SERVICE BULLETIN

N° **189-381**

ATA 11 – ADDITIONAL MARKINGS FOR CS26 AMDT 4 KIT INSTALLATION

This SB is applicable to all AW189 helicopters operating under EASA authority that make over water operations in accordance with point CAT.IDE.H.320(a) of Annex IV to Regulation (EU) No 965/2012.

Figure 1

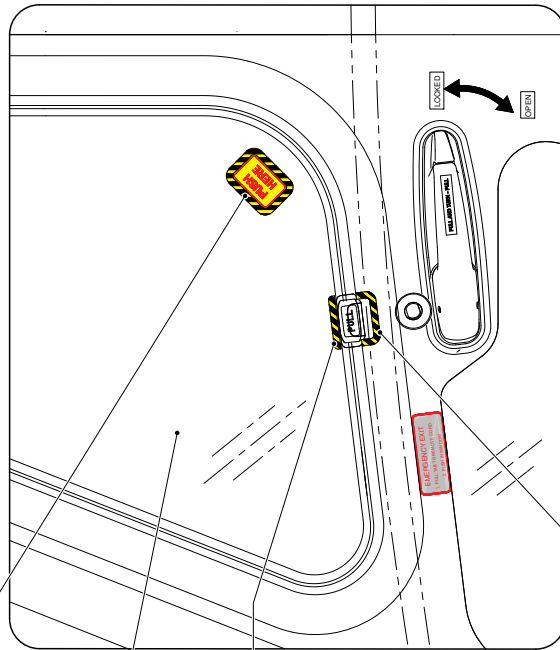
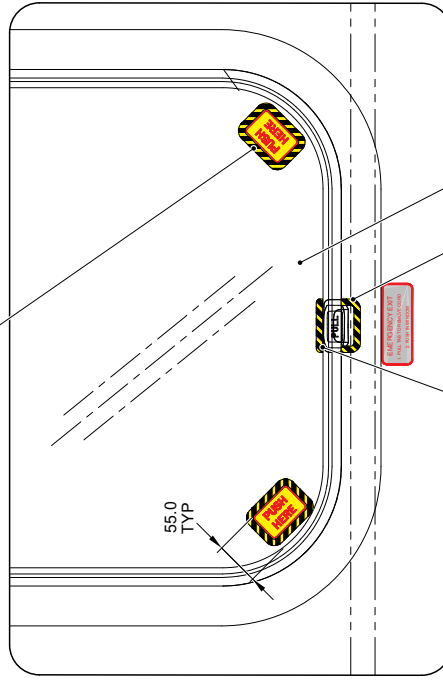
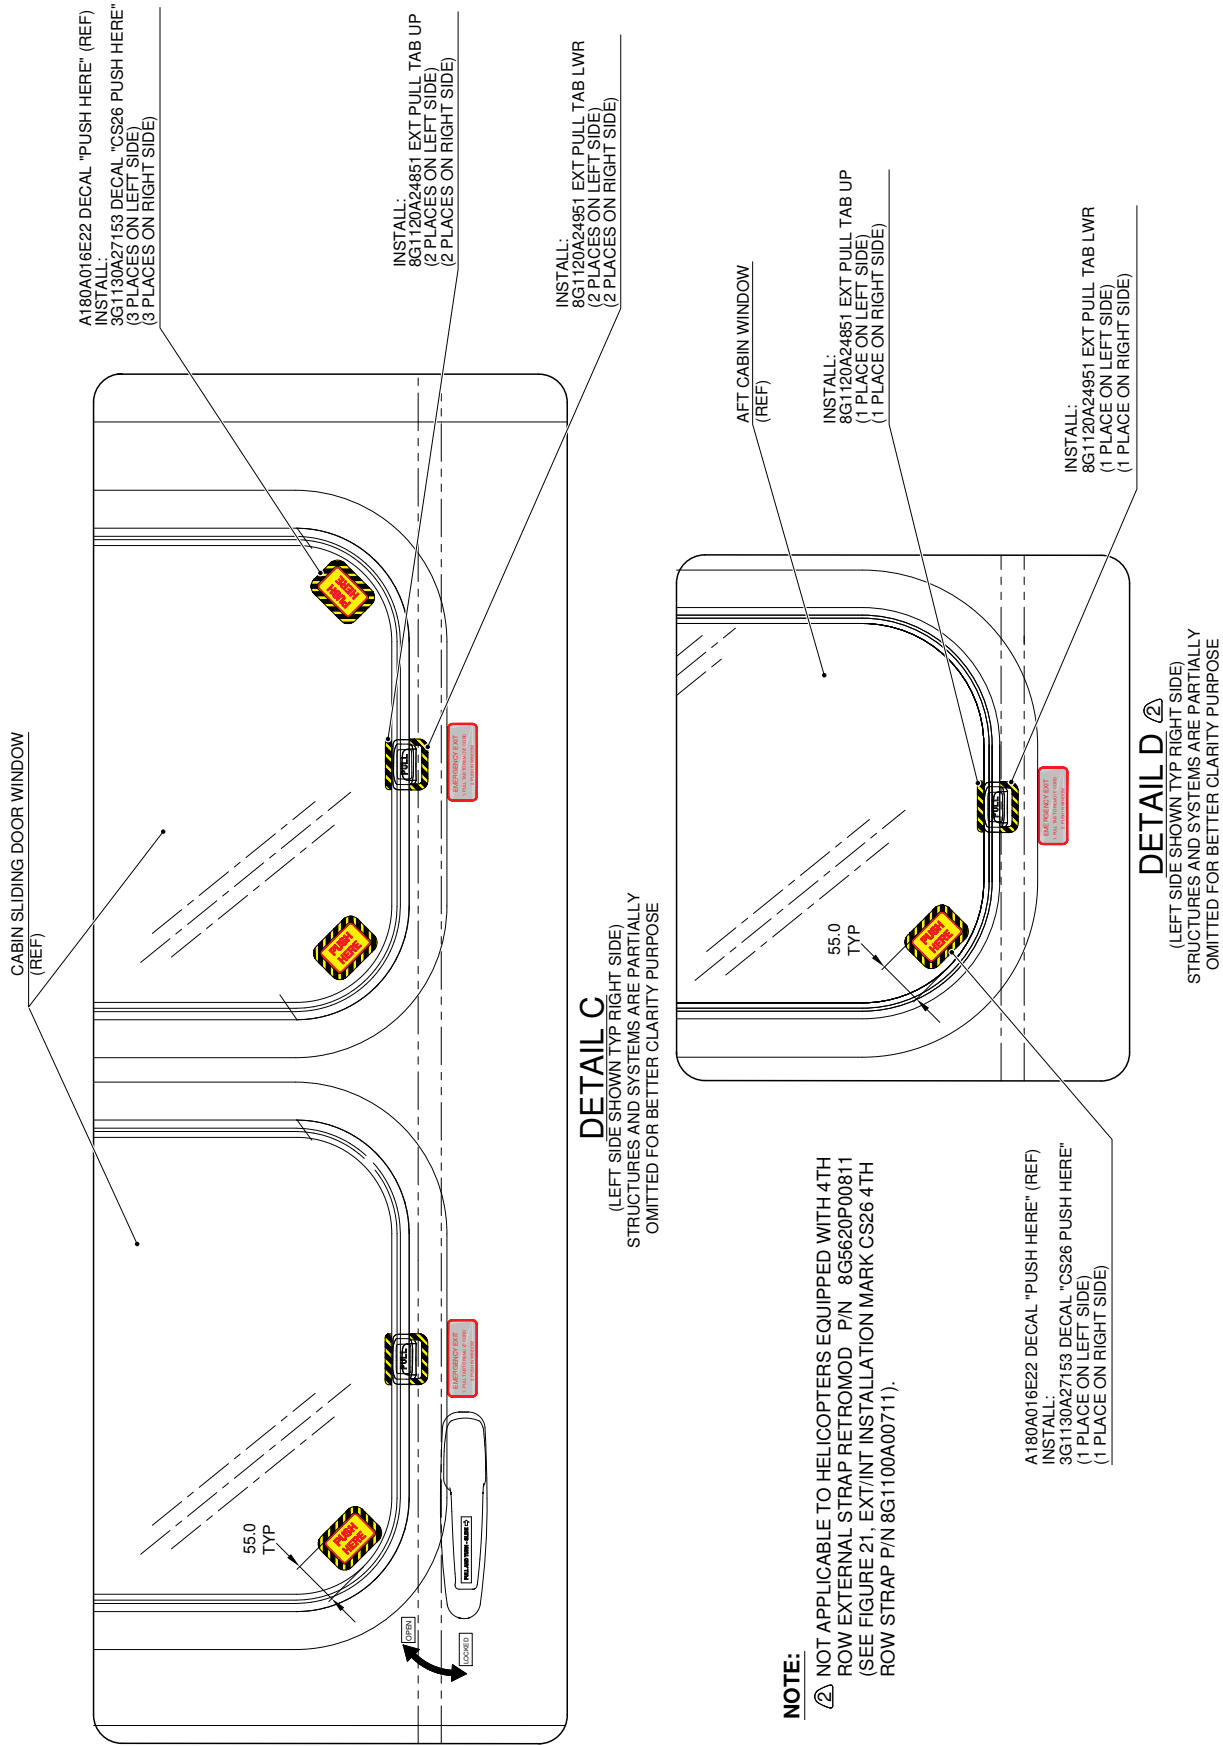
3. In accordance with AMP DM 89-A-11-00-01-00A-720A-A and with reference to Figure 1 Detail A, install the decal P/N 8G1120A24851 and the decal P/N 3G1130A27153 on the LH or RH cockpit door window.

4. In accordance with AMP DM 89-A-11-00-01-00A-720A-A and with reference to Figure 1 Detail B, install the decal P/N 8G1120A24951 on the LH or RH forward cabin window frame.

5. In accordance with AMP DM 89-A-11-00-01-00A-720A-A and with reference to Figure 1 Detail B, install the decal P/N 8G1120A24851 and n°2 decals P/N 3G1130A27153 on the LH or RH forward cabin window.

Figure 2

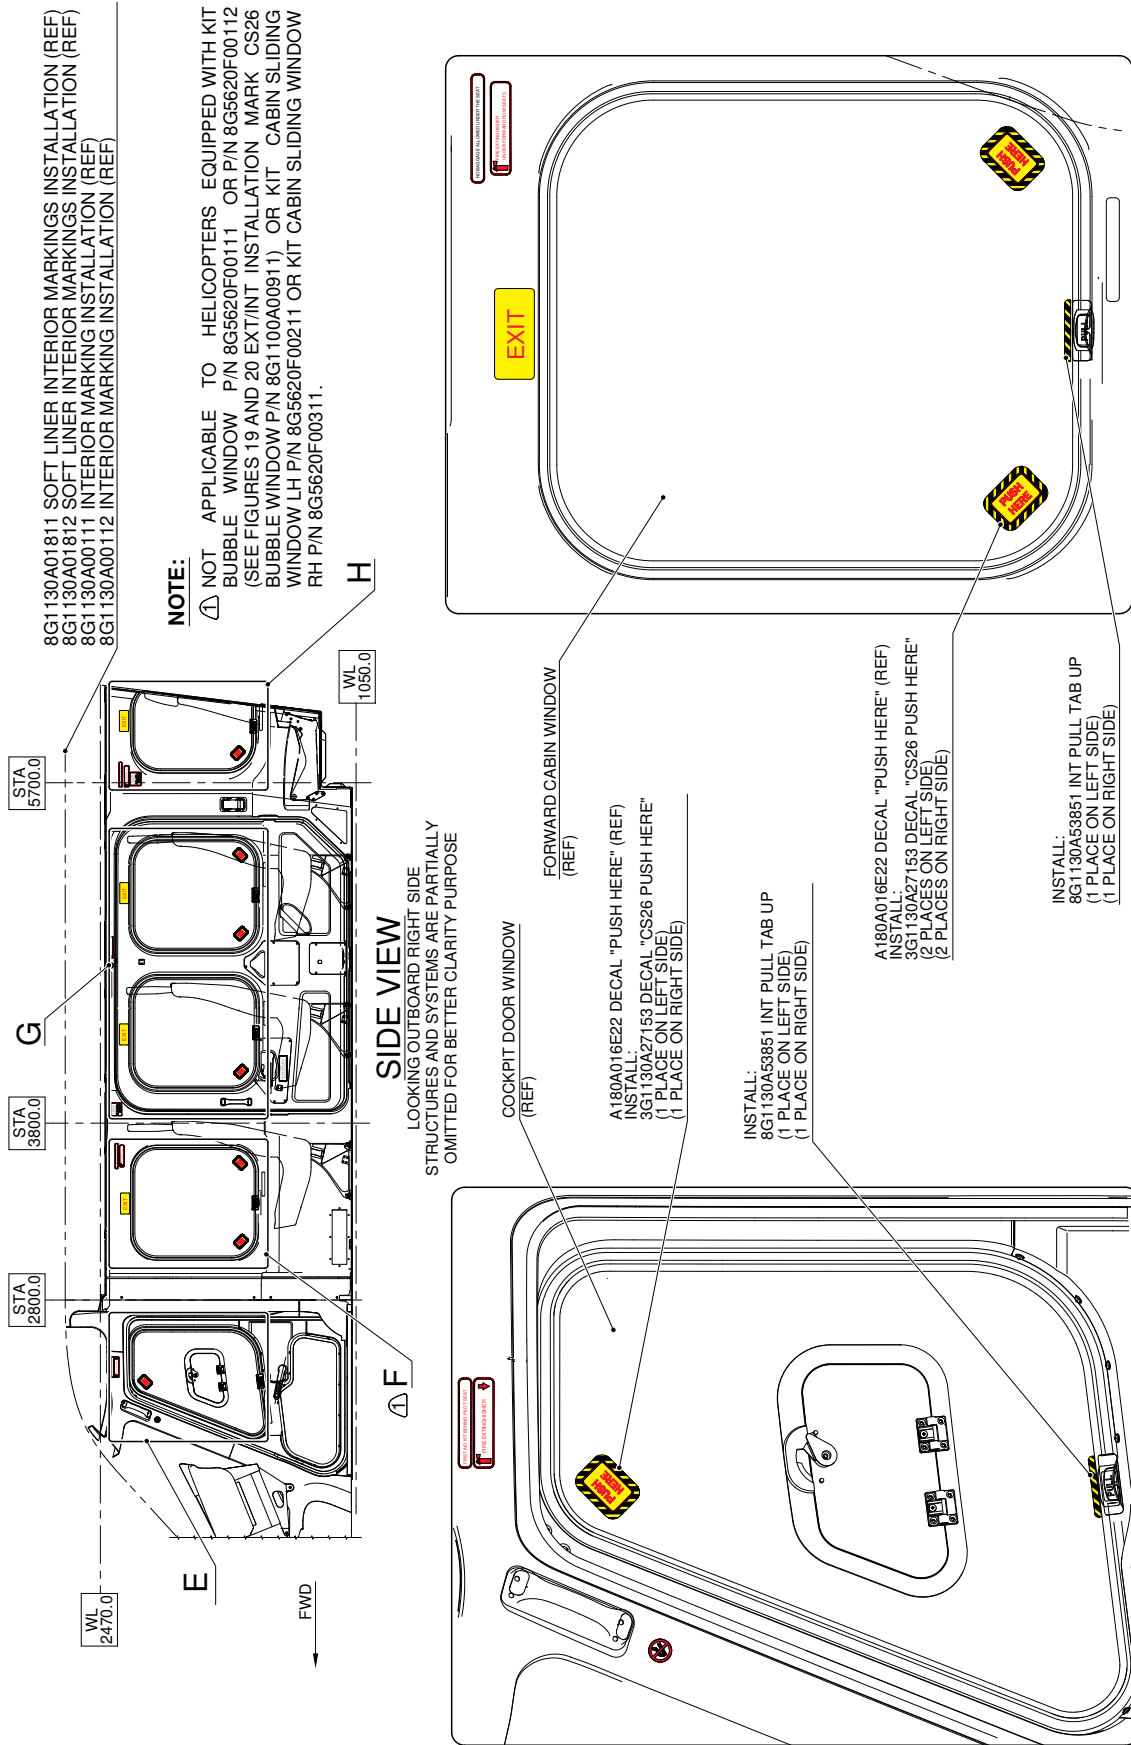
9. In accordance with AMP DM 89-A-11-00-01-00A-720A-A and with reference to Figure 2 Detail C, install n°2 decals P/N 8G1120A24851 and n°3 decals P/N 3G1130A27153 on the LH or RH cabin sliding door windows.

10. In accordance with AMP DM 89-A-11-00-01-00A-720A-A and with reference to Figure 2 Detail D, install the decal P/N 8G1120A24951 on the LH or RH aft cabin window frame.

11. In accordance with AMP DM 89-A-11-00-01-00A-720A-A and with reference to Figure 2 Detail D, install the decal P/N 8G1120A24851 and the decal P/N 3G1130A27153 on the LH or RH aft cabin window.

Figure 3

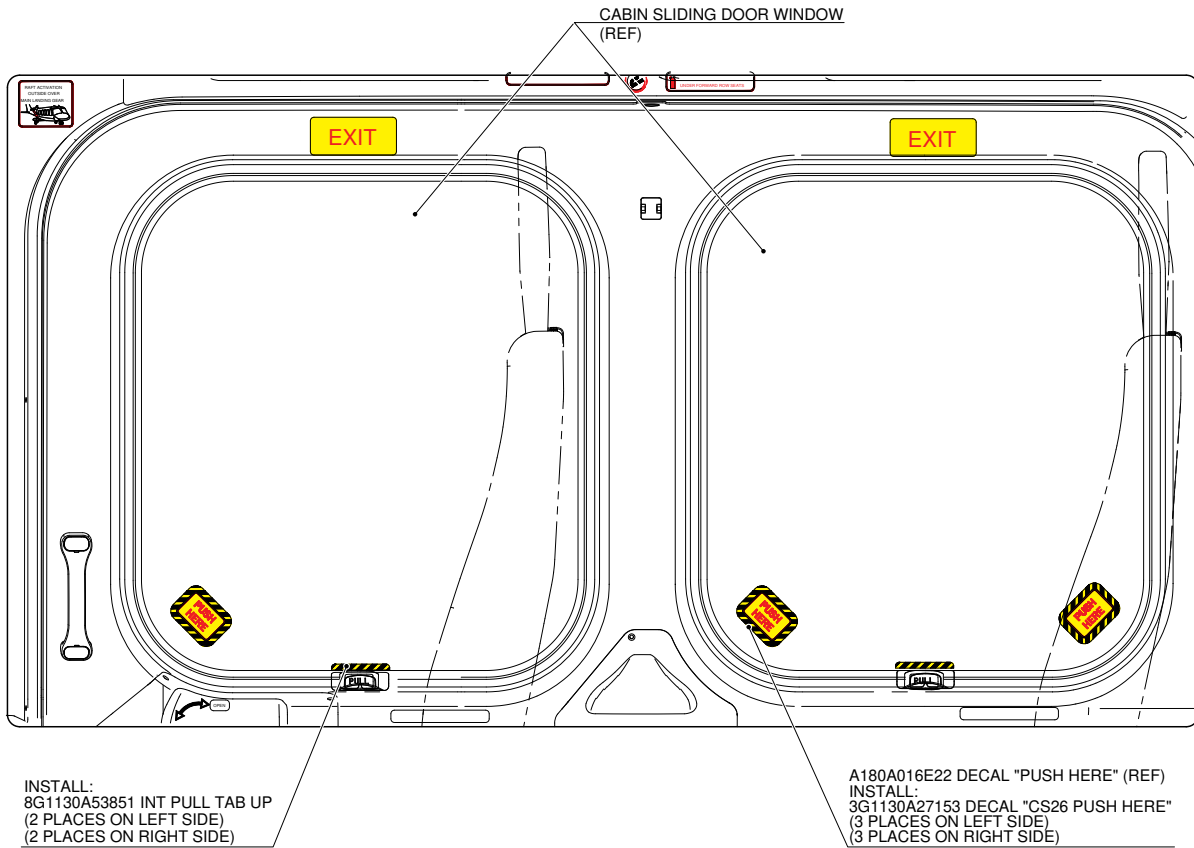
17. In accordance with AMP DM 89-A-11-00-01-00A-720A-A and with reference to Figure 3 Detail E, install the decal P/N 8G1130A53851 and the decal P/N 3G1130A27153 on the LH or RH cockpit door window.

18. In accordance with AMP DM 89-A-11-00-01-00A-720A-A and with reference to Figure 3 Detail F, install the decal P/N 8G1130A53851 and n°2 decals P/N 3G1130A27153 on the LH or RH forward cabin window.

Figure 4

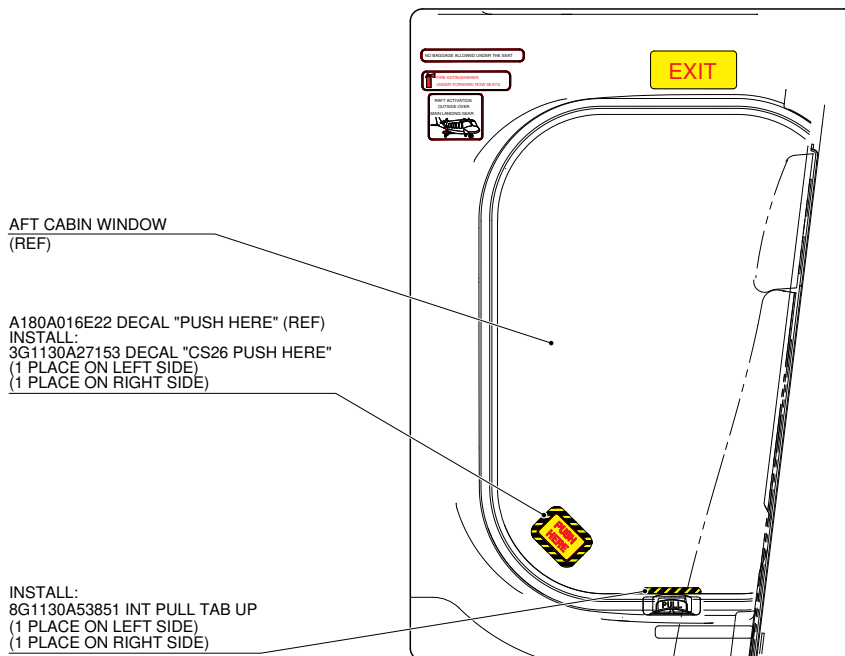
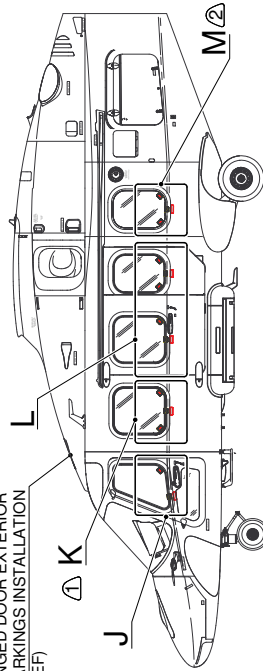
21. In accordance with AMP DM 89-A-11-00-01-00A-720A-A and with reference to Figure 4 Detail G, install n°2 decals P/N 8G1130A53851 and n°3 decals P/N 3G1130A27153 on the LH or RH cabin sliding door windows.

22. In accordance with AMP DM 89-A-11-00-01-00A-720A-A and with reference to Figure 4 Detail H, install the decal P/N 8G1130A53851 and the decal P/N 3G1130A27153 on the LH or RH aft cabin window.
23. Repeat steps 2 thru 22 for the other side of the helicopter.
24. Return the helicopter to flight configuration and record for compliance with Part I of this Service Bulletin on the helicopter logbook.
25. Gain access to My Communications section on Leonardo WebPortal and compile the “Service Bulletin Application Communication”.

Figure 5

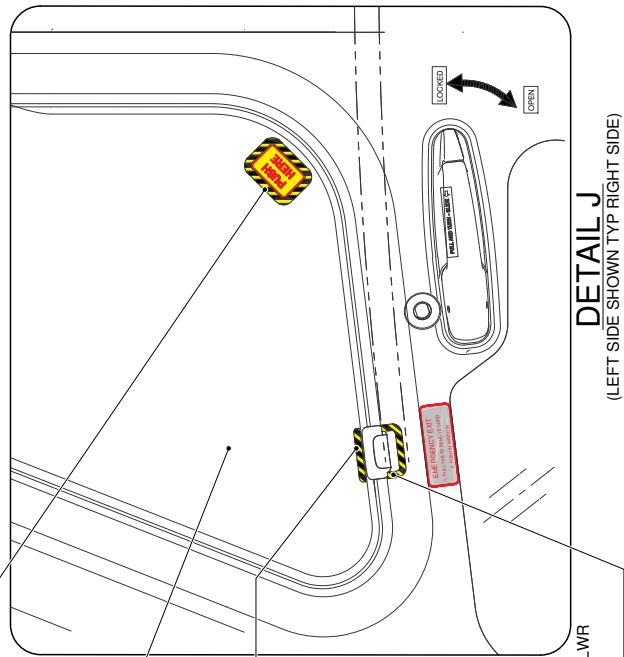
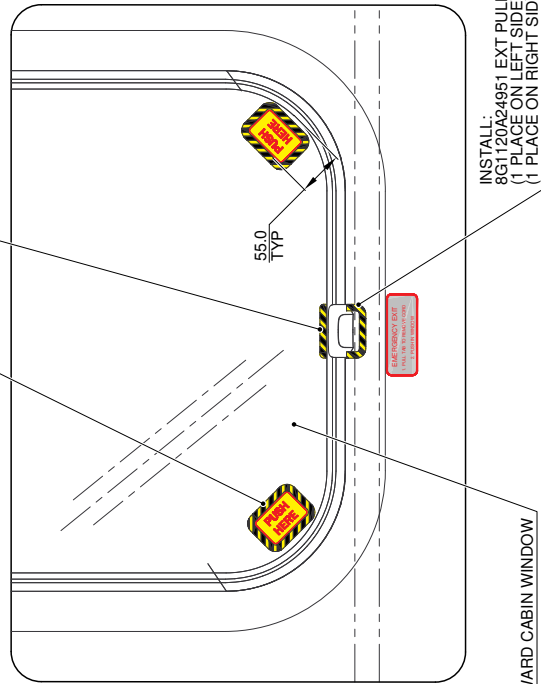
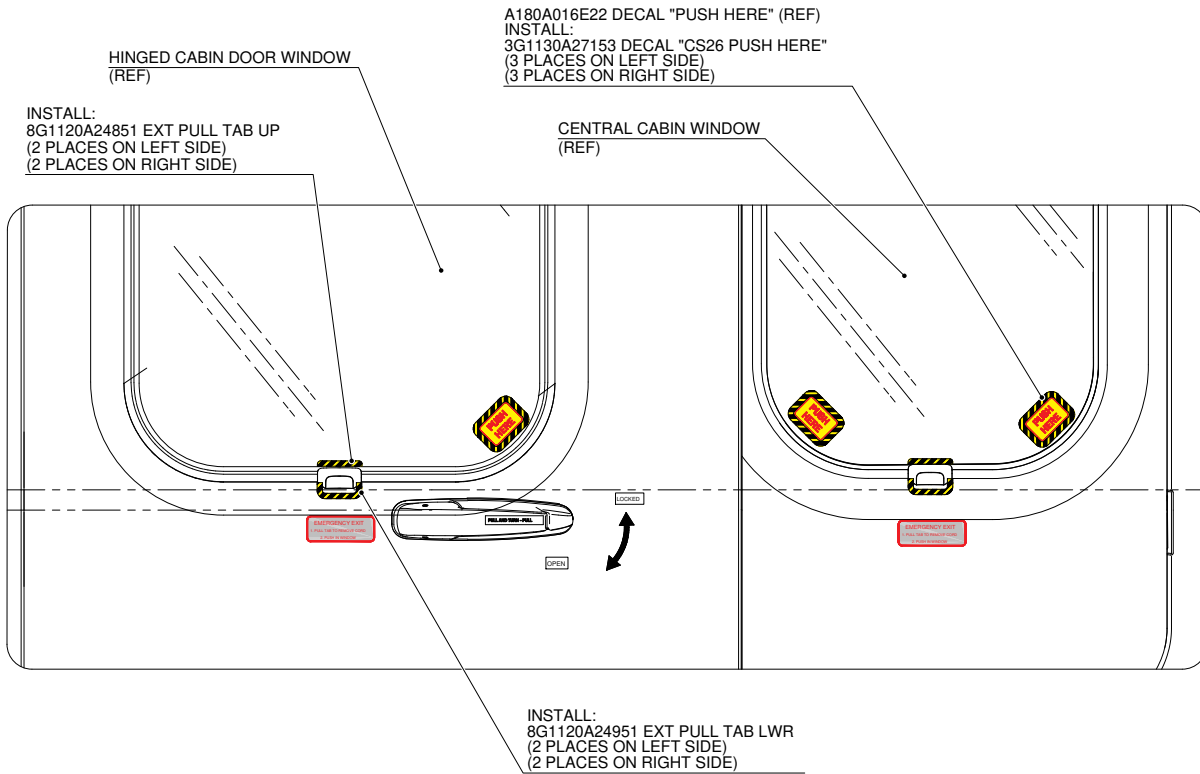
3. In accordance with AMP DM 89-A-11-00-01-00A-720A-A and with reference to Figure 5 Detail J, install the decal P/N 8G1120A24851 and the decal P/N 3G1130A27153 on the LH or RH cockpit door window.

4. In accordance with AMP DM 89-A-11-00-01-00A-720A-A and with reference to Figure 5 Detail K, install the decal P/N 8G1120A24951 on the LH or RH forward cabin window frame.

5. In accordance with AMP DM 89-A-11-00-01-00A-720A-A and with reference to Figure 5 Detail K, install the decal P/N 8G1120A24851 and n°2 decals P/N 3G1130A27153 on the LH or RH forward cabin window.

Figure 6

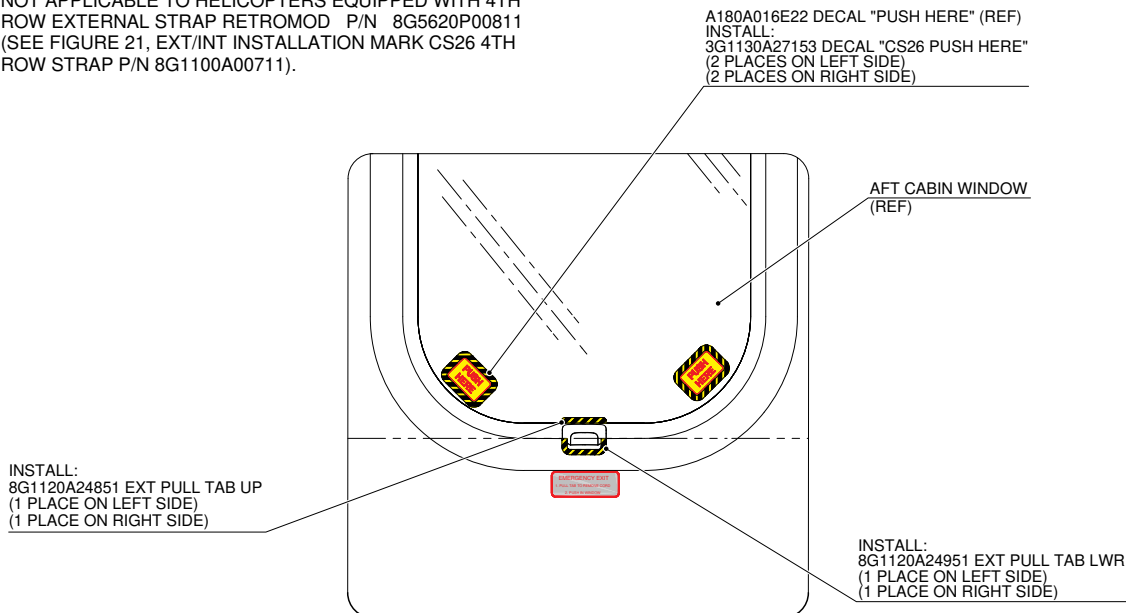
9. In accordance with AMP DM 89-A-11-00-01-00A-720A-A and with reference to Figure 6 Detail L, install the decal P/N 8G1120A24851 and the decal P/N 3G1130A27153 on the LH or RH hinged cabin door window.
10. In accordance with AMP DM 89-A-11-00-01-00A-720A-A and with reference to Figure 6 Detail L, install the decal P/N 8G1120A24951 on the LH or RH central cabin window frame.

11. In accordance with AMP DM 89-A-11-00-01-00A-720A-A and with reference to Figure 6 Detail L, install the decal P/N 8G1120A24851 and n°2 decals P/N 3G1130A27153 on the LH or RH central cabin window.

12. In accordance with AMP DM 89-A-11-00-01-00A-720A-A and with reference to Figure 6 Detail M, install the decal P/N 8G1120A24951 on the LH or RH aft cabin window frame.

13. In accordance with AMP DM 89-A-11-00-01-00A-720A-A and with reference to Figure 6 Detail M, install the decal P/N 8G1120A24851 and n°2 decals P/N 3G1130A27153 on the LH or RH aft cabin window.
